UNITED STATES ENVIRONMENTAL PROTECTION AGENCY
REGION V
12th STREET LANDFILL SITE
~~WEST CHESTER, PENNSYLVANIA~~
~~WORK ASSIGNMENT NO. \\\\ \\\\ \\\\~~

PREPARATORY GRADING PLAN
PHASE II

U.S. ENVIRONMENTAL PROTECTION AGENCY
12th STREET LANDFILL SITE
WILMINGTON DELAWARE

PREPARATORY GRADING PLAN
PHASE II

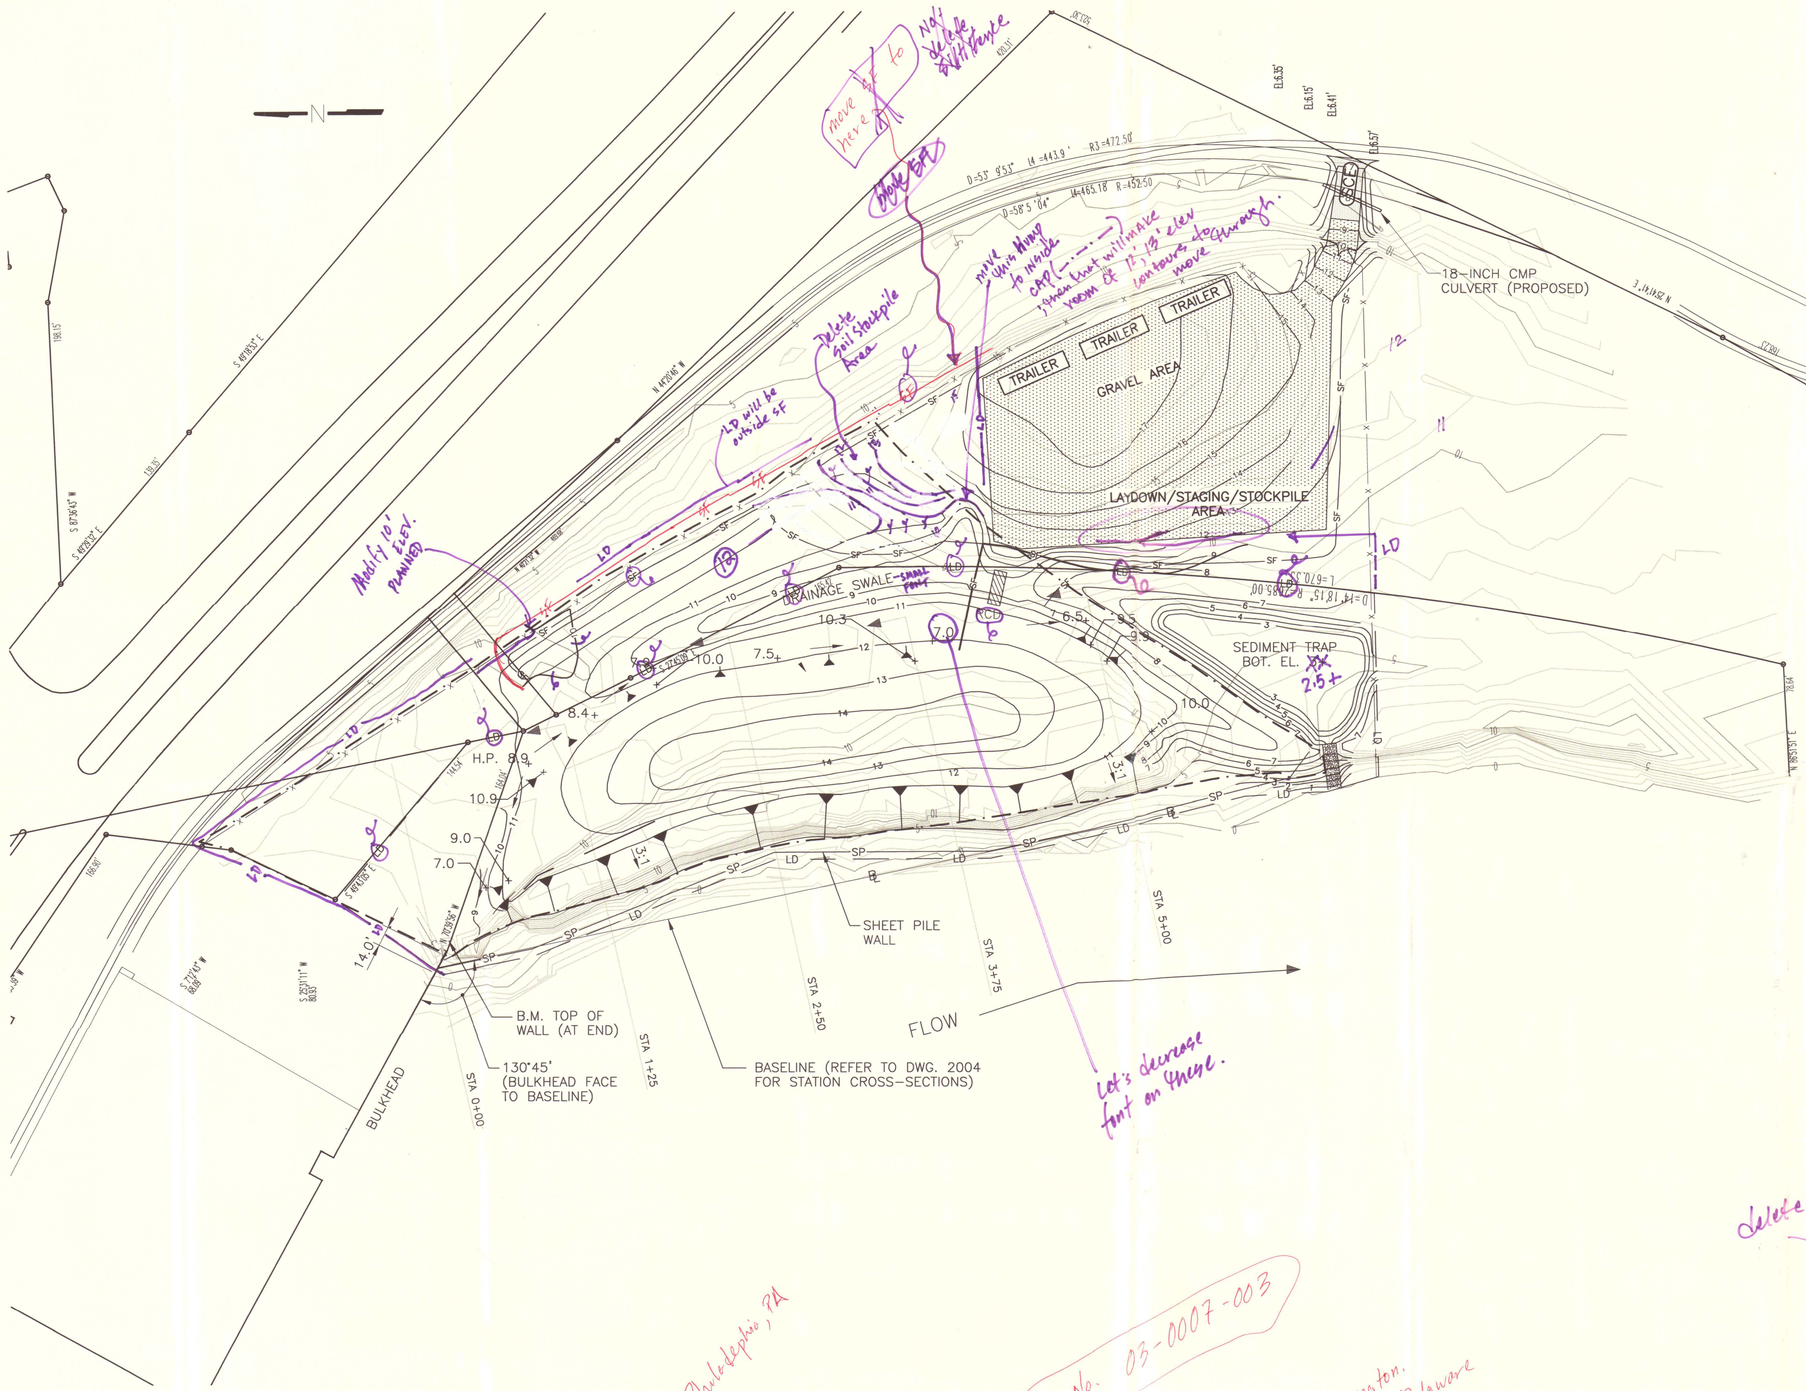
1. INITIATE CUT-BACK EXCAVATION OF CREEK BANK TO 3:1 (HORIZONTAL TO VERTICAL) SLOPE.
2. MAINTAIN ~~SLPE OF AT LEAST %~~ ALONG DREAINAGE SWALE.

UNINTERRUPTED POSITIVE GRADE

MOVE ~~Bring up~~ "—LD—" ~~again~~. This is limit of disturbance and should rest immediately outside any of our features. (eg SF, ~~[illegible]~~, CAP LIMIT) You might have to move it out in some areas

- delete all silt fence

take out

delete all of these

- List weston as Source

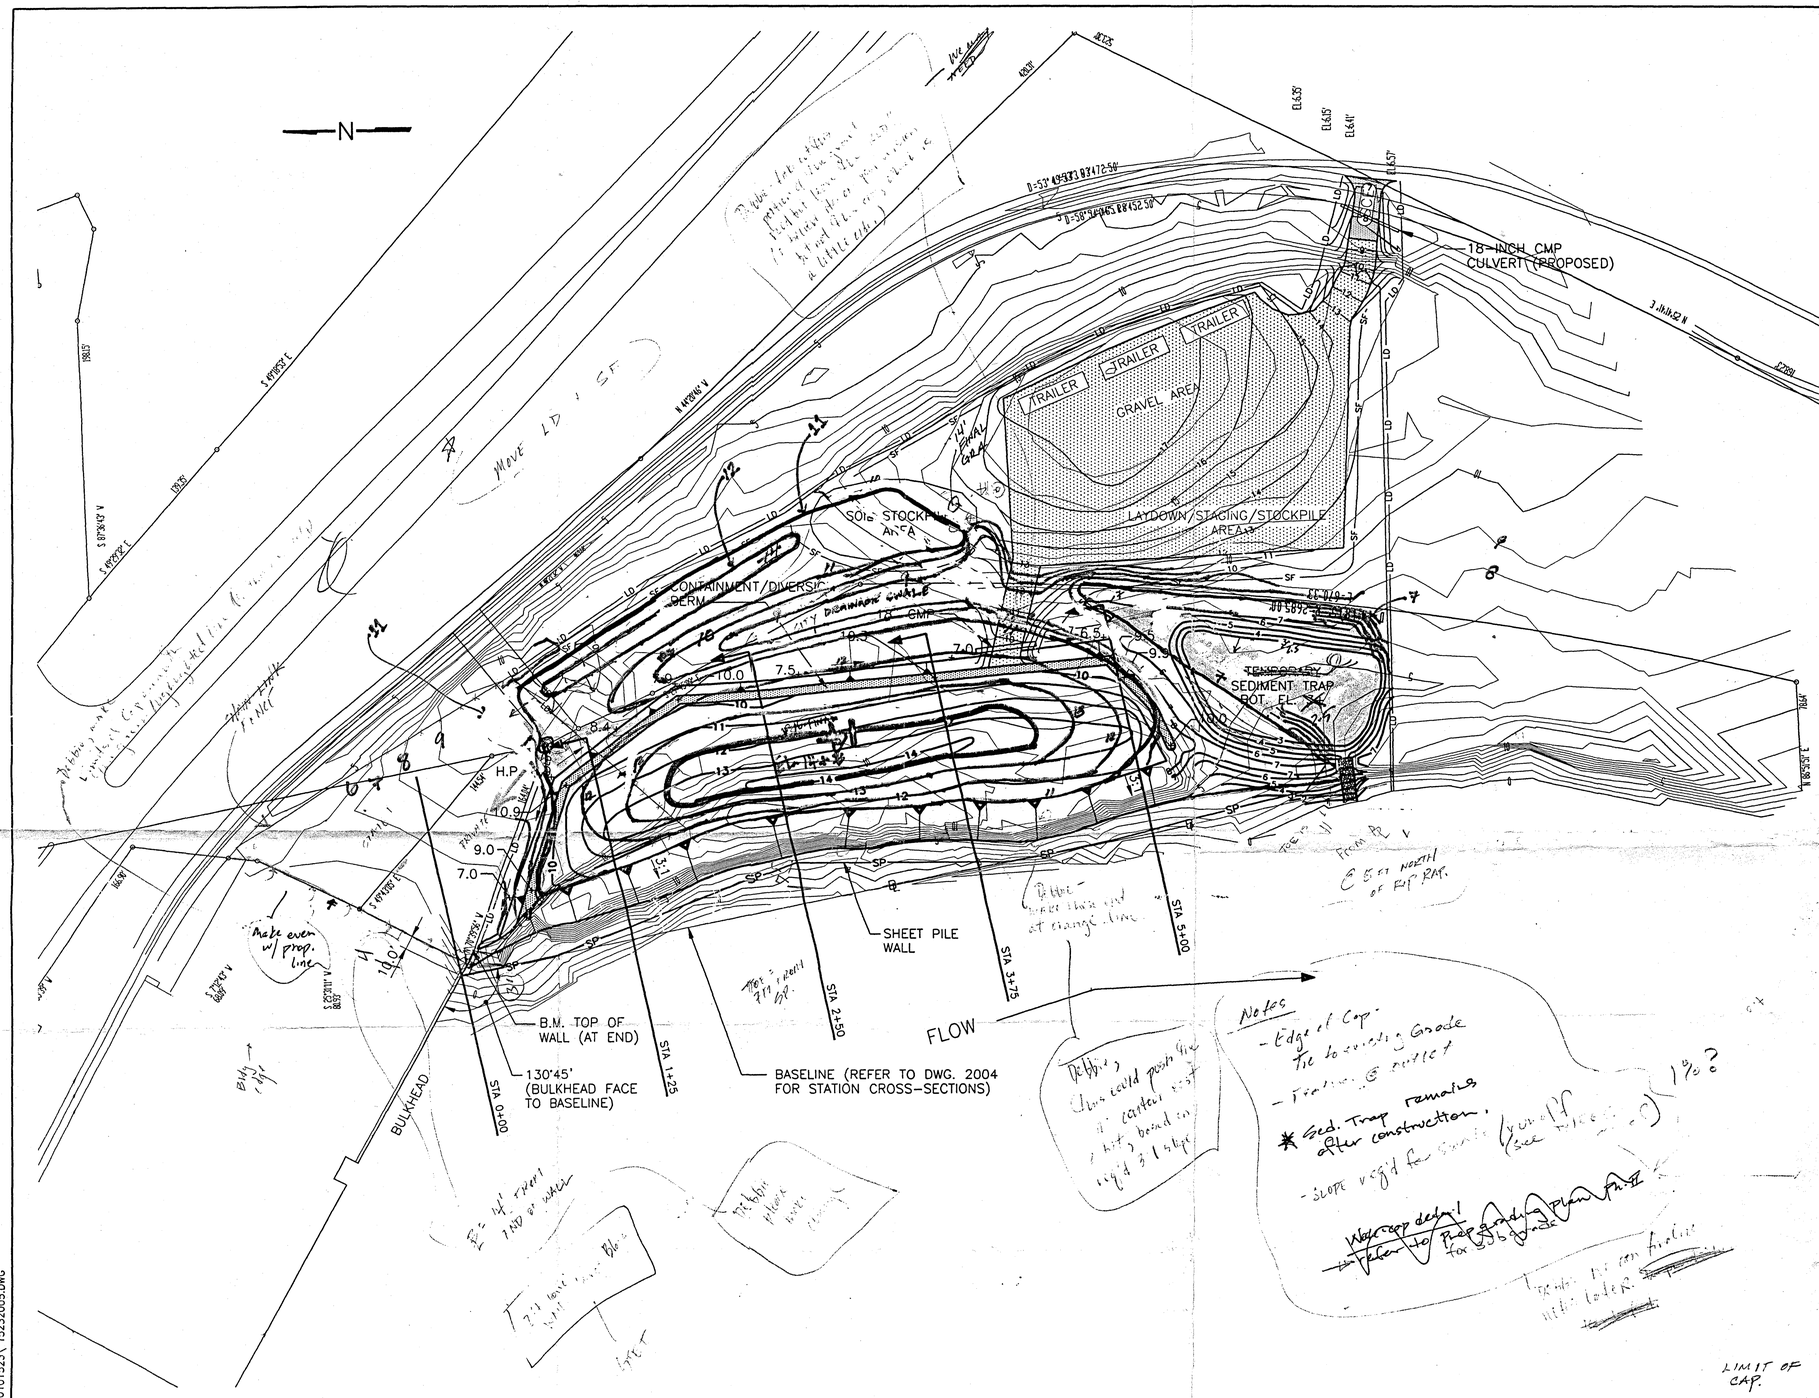
1. Keep.

2. MAINTAIN SLOPE OF AT LEAST — % ALONG DRAINAGE SWALE
